PIERGIORGIO BERUTO

IEEE 802.3cg
Clause 148 cleanup
September 9th, 2019

Fixes to Fig. 148-3 (PLCA Control State Diagram)

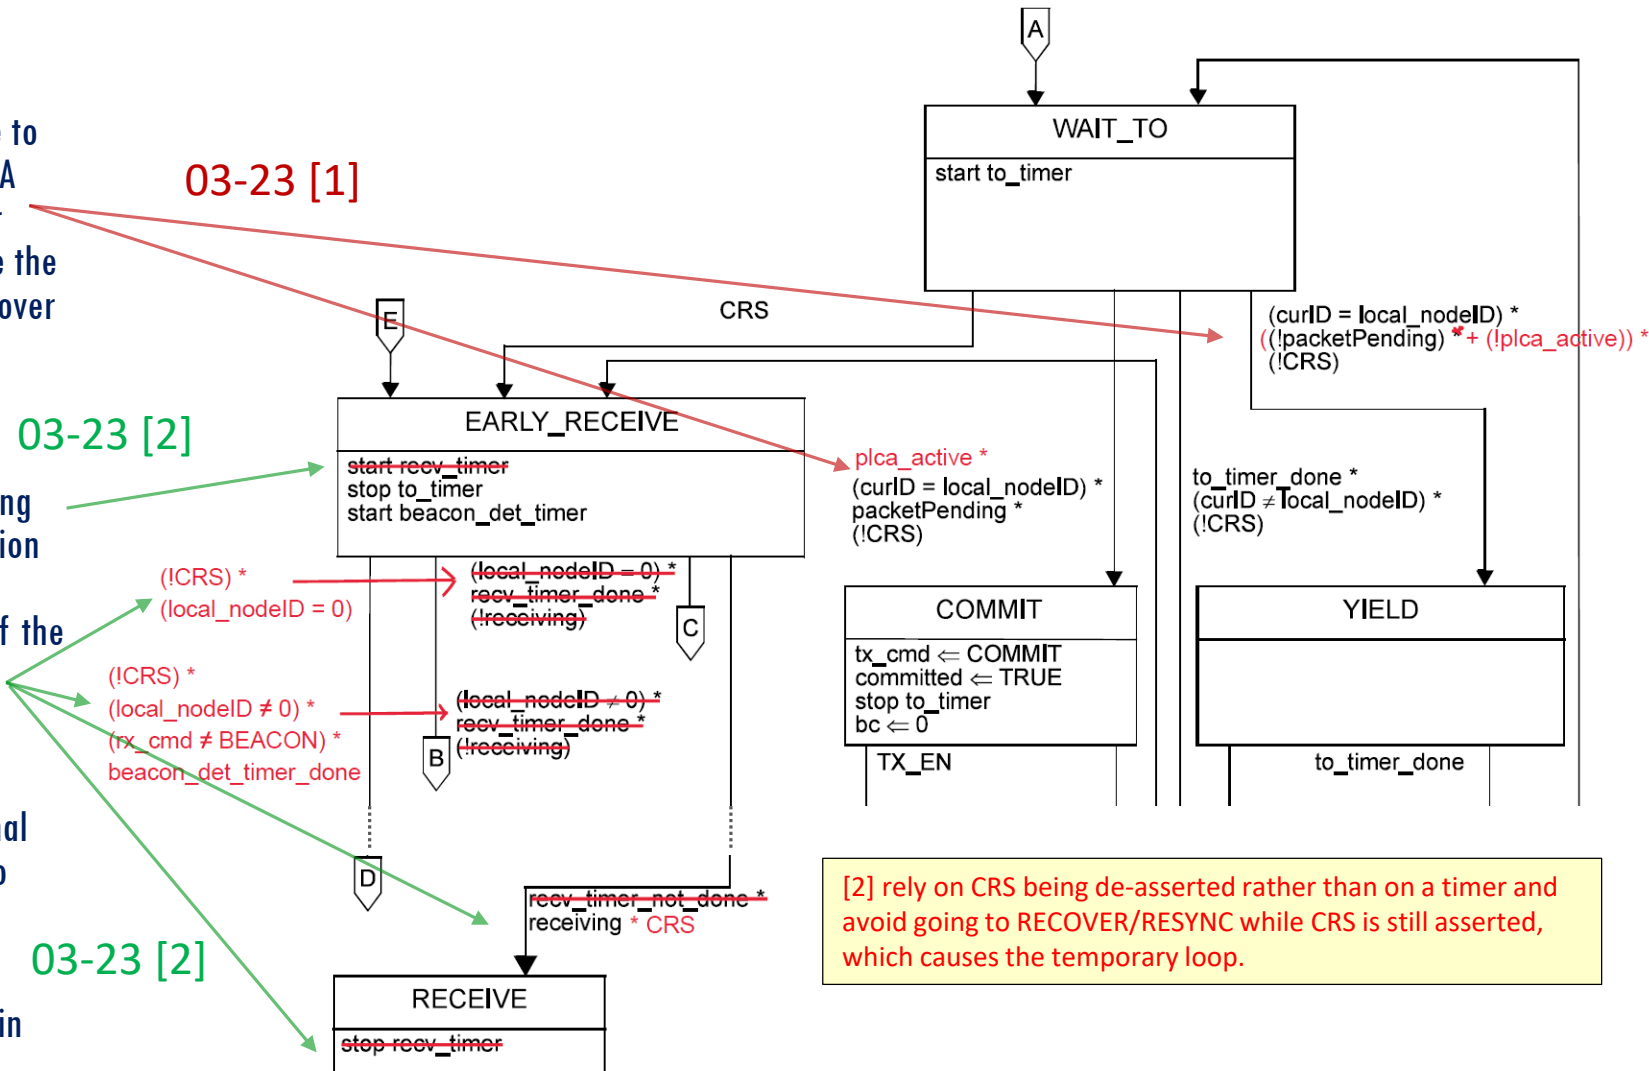
[1] The node with $\text{local_nodeID} = 0$ may not be able to send a BEACON in the unlikely situation that non-PLCA enabled nodes keep sending packets at a rate higher than the recv_beacon_timer expiration. In such case the PLCA Control State diagram would be stuck in the recover state.

[2] The Control state diagram may loop from EARLY_RECEIVE and RESYNC state because of CRS being continuously asserted. This may cause a false detection of the BEACON if the recv_timer elapses when $\text{CRS} = \text{TRUE}$ at the end of a packet where the length of the CRS is compatible with the length of a BEACON.

[3] The BEACON may not be sent when PLCA is first enabled due to the Data state diagram being in normal state with $\text{plca_status} = \text{FAIL}$, preventing this one to become OK.

[4] Achieve proper synchronization with MII TX_CLK in the PLCA Data State Diagram

Figure 148-4—PLCA Data state diagram

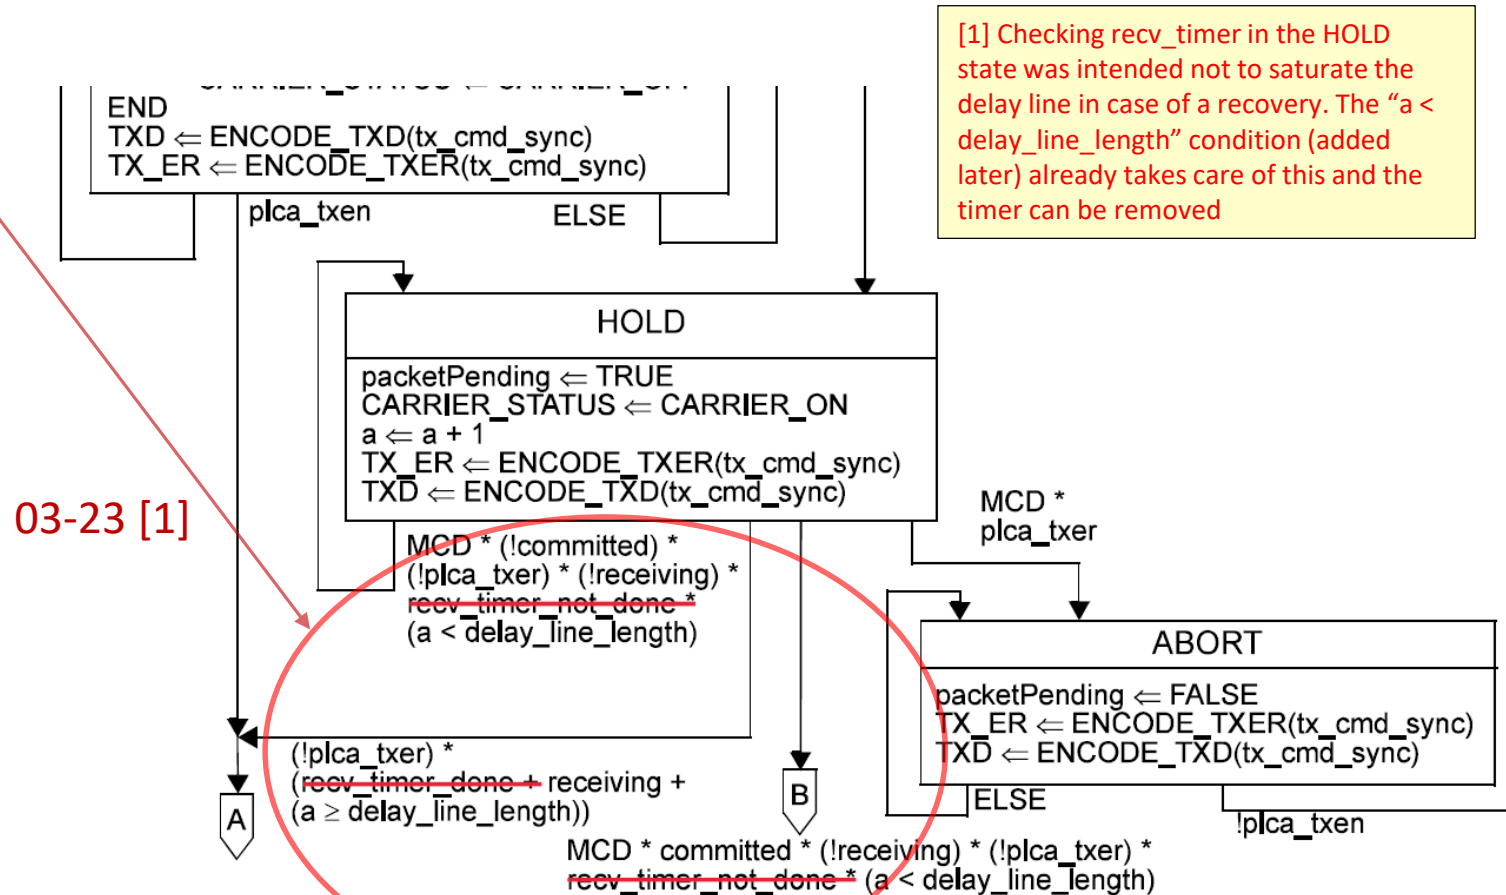
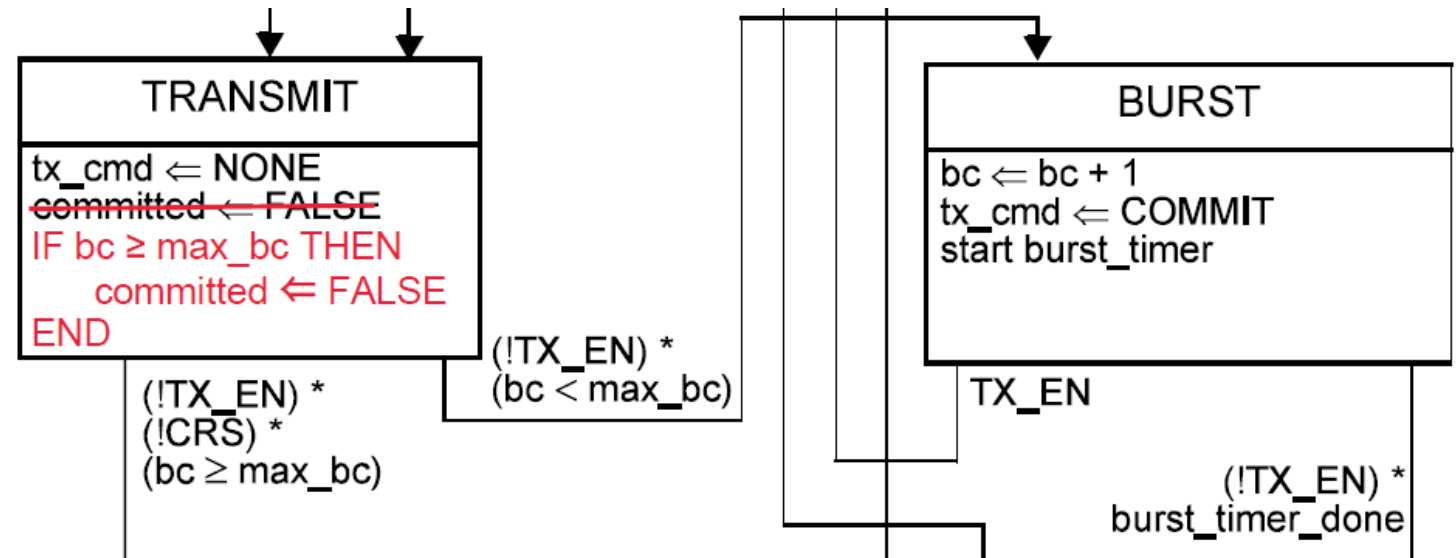
[1] According to Clause 147 PCS Receive State Diagram the COMMIT request is looped back into a COMMIT indication via MII. If the implementation does not handle this correctly, the burst mode may not work (always trigger a collision). An additional state is required to clarify the behavior of the state diagram when bursting.

Fixes to Fig. 148-3 (PLCA Control State Diagram)

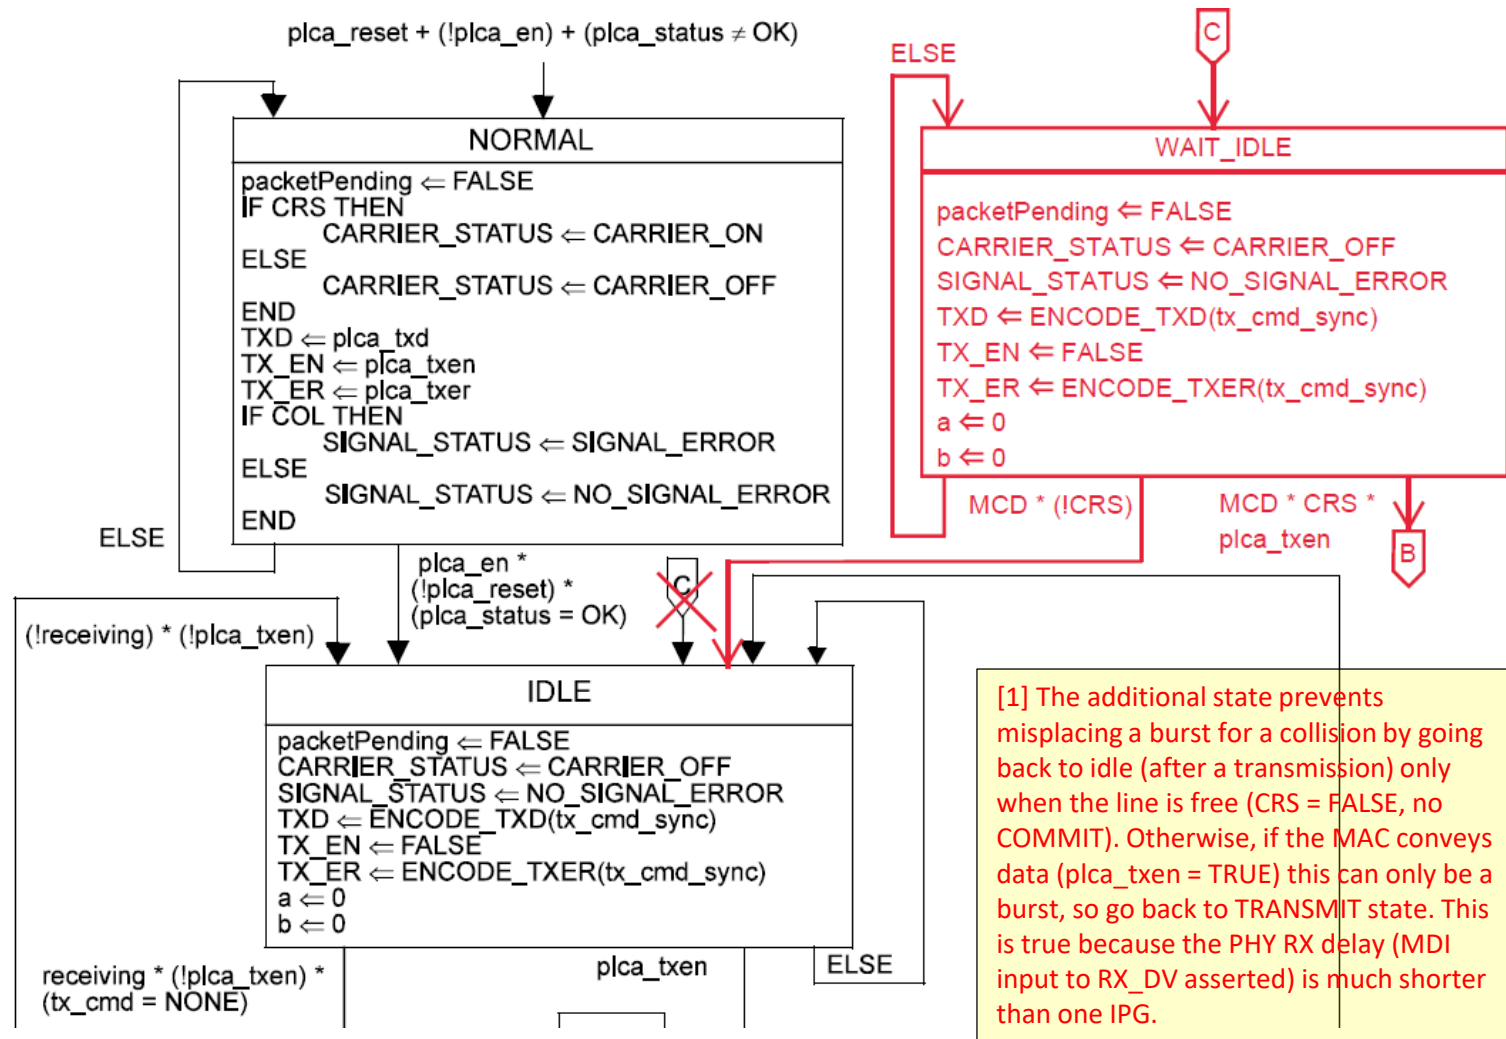
[5] setting the "committed" variable to FALSE, unconditionally, may prevent the PLCA Data State Diagram from bursting.

[5] just keep the committed variable set during a burst, so that the DATA Stat Diagram will always be able to send
